**RIVERDALE CITY PLANNING COMMISSION AGENDA
CIVIC CENTER - 4600 S. WEBER RIVER DR.
TUESDAY – FEBRUARY 14, 2023**

SUBJECT: Consideration of Preliminary Subdivision and Site Plan request for WDG Riverdale Subdivision and Riverdale Apartments Site Plan located at approximately 691 West 4400 South, as requested by Wright Development Group.

Plan Review For Riverdale Apartments

Attn: Mike Eggett, Community Development Director/RDA Deputy Executive Director
Proj: **Riverdale Apartments – 700 West & 4400 South Street**
Subj: Plat and Improvement Drawing Review

Grading Plan
SHEET
C300

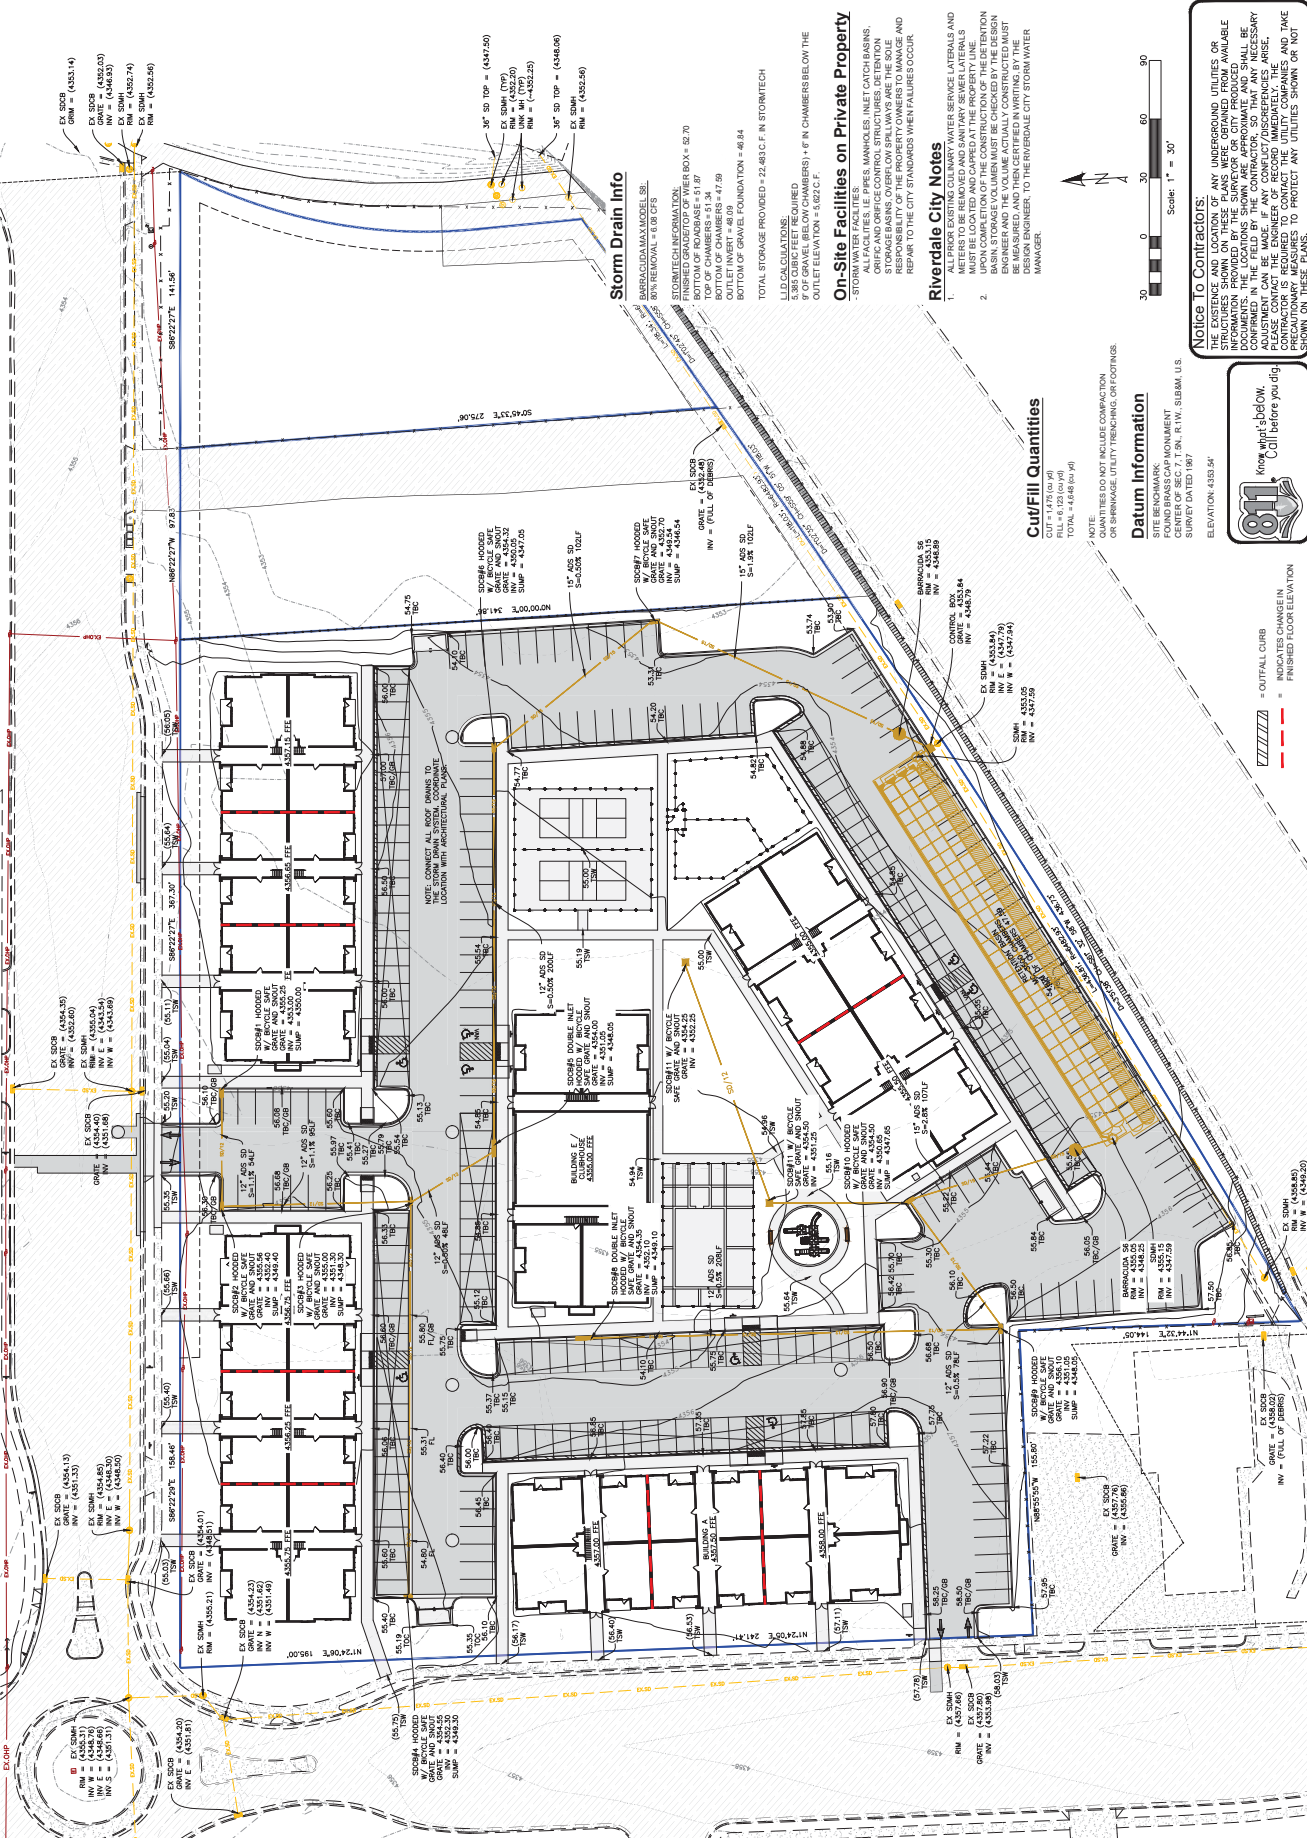
- The storm drain pipe that the subdivision is planning to connect to is a UDOT line. A letter from UDOT approving connection is required.
- According to the notes on the drawings the existing storm drain pipe, that is planned for final connection, has debris in it, pipe will need to be cleaned prior to connection.
- An injection well permit will need to be obtained for the proposed storm drain storage system.
- A storm water "Maintenance Chart/Record" needs to be created and placed in the improvement drawings for the on-site maintenance workers to follow. The Maintenance Chart/Record must be available for the Riverdale City Storm Water Manager to review upon request.

Grading Plan

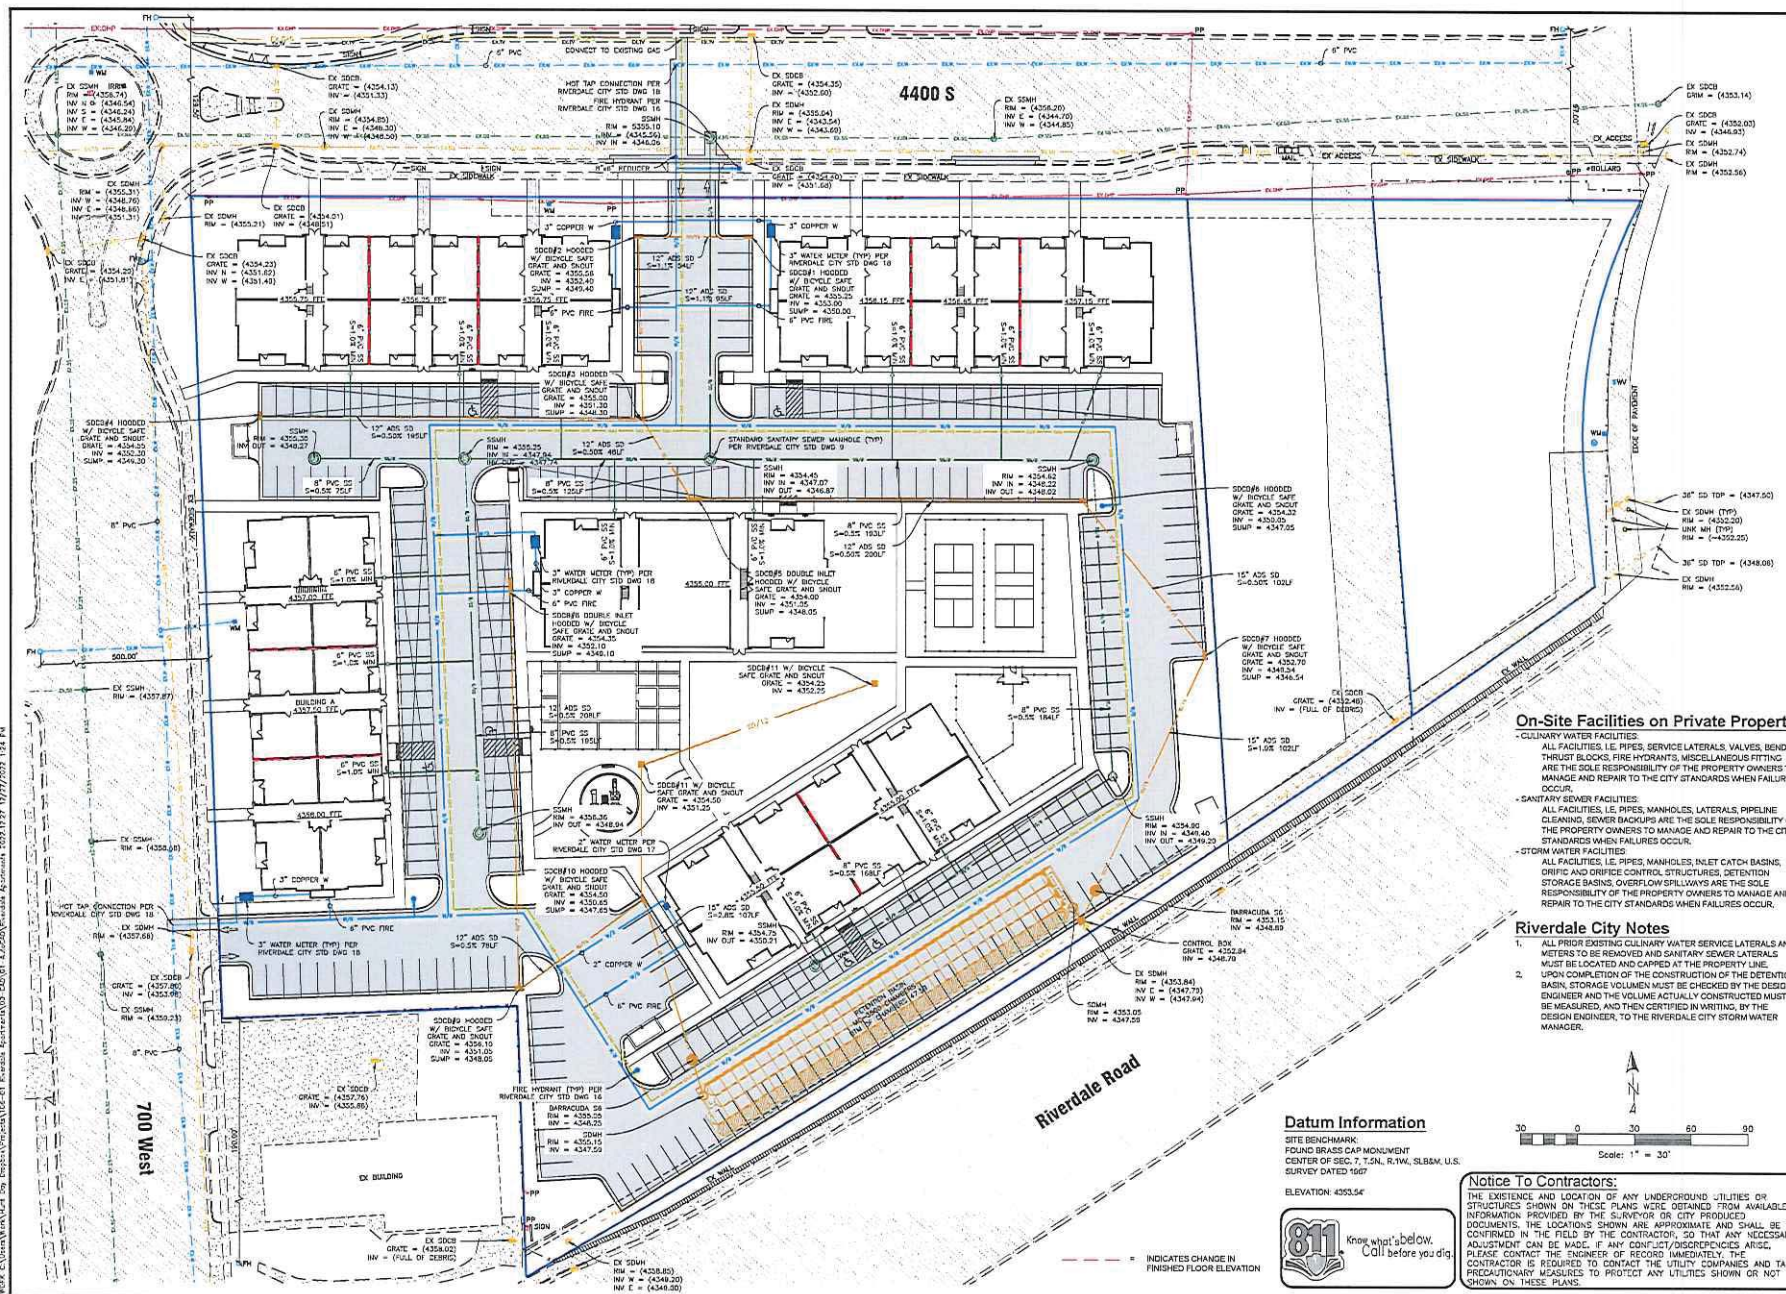
1. Point of Beginning needs to be added to the Plat.
2. The “Boundary Description” does not match what is on the plat and does not close.
3. Adjacent parcels need to be identified with parcel numbers and ownership.
4. Adjacent roadways need to be identified.
5. Dates on the plat need to be updated.
6. All utility easements should be evaluated and updated to match proposed subdivision.
7. An address for the site should be created for the new buildings.
8. The 100-year flood plain will need to be identified and the finish floor of all residential units will need to be 12” above the flood elevation.
